# Service Bulletin

**Model:** CDX-U404/U606 **No.** 292

**Subject:** Preventing Audio Dropouts **Date:** August 25, 1993

[SERVO BOARD]

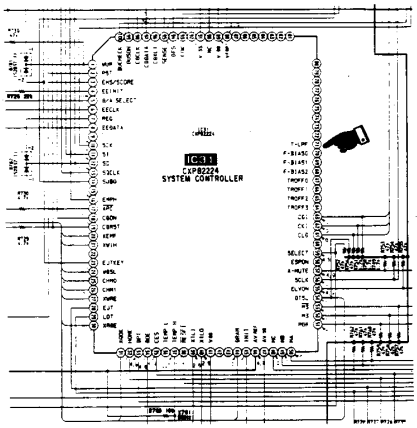
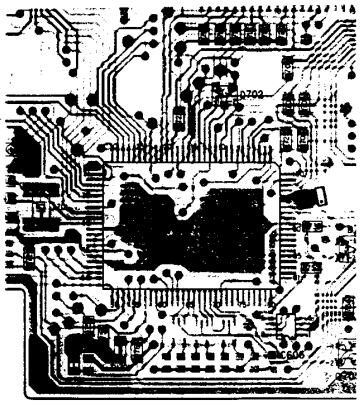
(51) Audio dropouts occur without any relation to vibration of the vehicle or scratches on the disc.

**Solution:** Replace IC31 on the Servo board with the improved type shown below.

| REF | FORMER | | NEW | |
|---|---|---|---|---|
| IC31 | IC, CXP82224-003Q | 8-752-843-14 | IC, CXP82224-008Q | 8-752-850-17 |
